SC Housing Accessibility Consultant Qualifications and Requirements

Nexus Vue Apartments
Spartanburg, SC

**RE: Accessibility Plan Review Report
Nexus Vue Apartments**
W. Blackstock Road & Morning Circle
Spartanburg, SC
Terracon Project Number F8226212

Re: **ACCESSIBILITY PLAN REVIEW REPORT**
Battery Park Senior Apartments
1 Battle Square
Asheville, North Carolina 28801
NCHFA Project Number TBD
Terracon Project Number F8216301

Field Issue | Sahand Saljooghi | Restroom-Public
Plan: A3.1 - COMMUNITY BUILDING FLOOR PLANS AND SCHEDULES

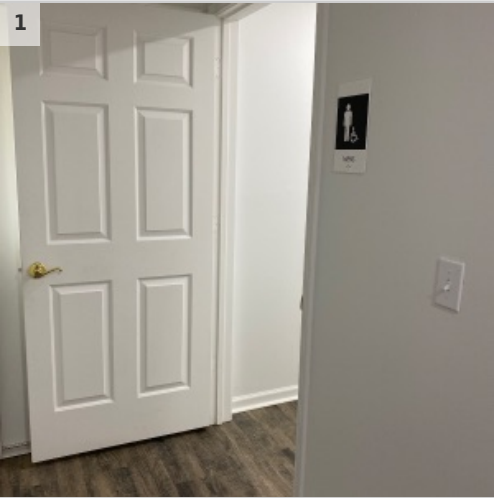
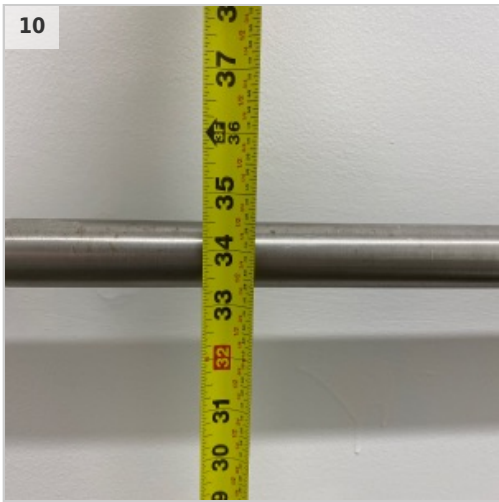
Sahand Saljooghi	Photo 1	02 Feb 09:06 AM
Sahand Saljooghi	Photo 2	02 Feb 09:06 AM
Sahand Saljooghi	Photo 3	02 Feb 09:07 AM
Sahand Saljooghi	Photo 4	02 Feb 09:07 AM
Sahand Saljooghi	Photo 5	02 Feb 09:07 AM
Sahand Saljooghi	Photo 6	02 Feb 09:07 AM
Sahand Saljooghi	Photo 7	02 Feb 09:07 AM
Sahand Saljooghi	Photo 8	02 Feb 09:07 AM
Sahand Saljooghi	Photo 9	02 Feb 09:07 AM
Sahand Saljooghi	Photo 10	02 Feb 09:08 AM
Sahand Saljooghi	Issue: The paper tower dispenser is 54" above finish floor and should be lowered to a minimum of 48".	02 Feb 09:09 AM

#31 - Unit Type Bhcs Unit# 106
Field Issue | Sahand Saljooghi | Unit-Mobility
Plan: A1.4 - UNIT BHCS FLOOR PLANS & NOTES

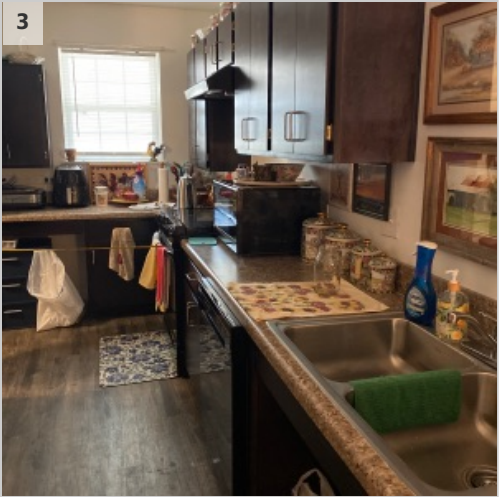
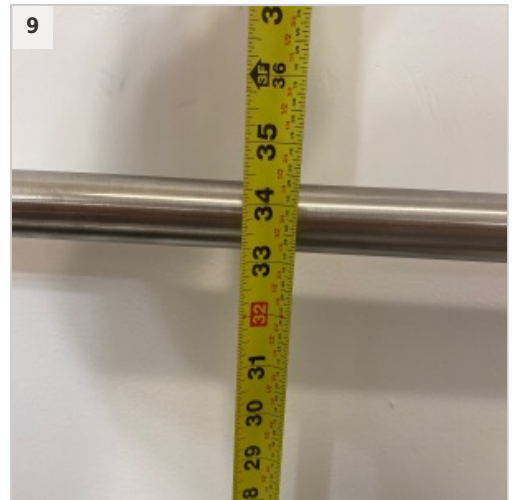
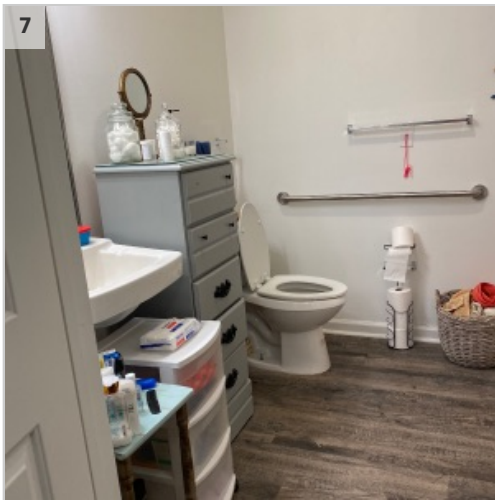
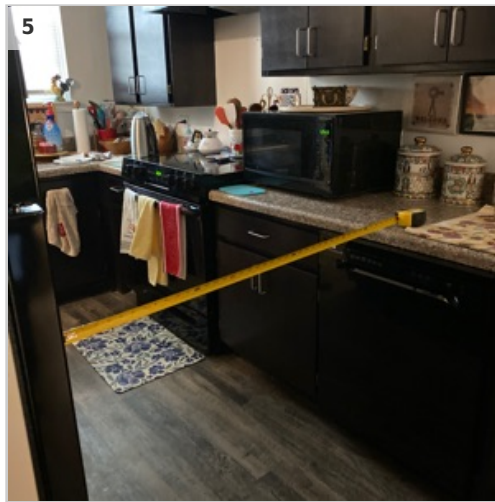
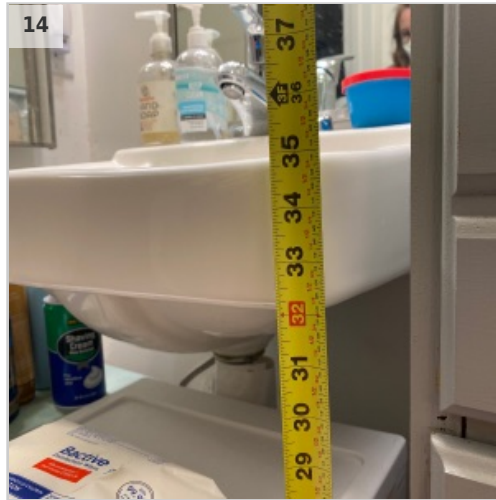
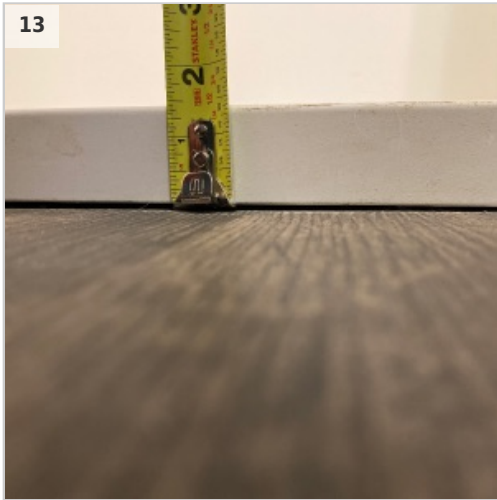
Sahand Saljooghi	Issue: The lavatory is greater than 34" to the top surface and should be lowered.	02 Feb 10:23 AM
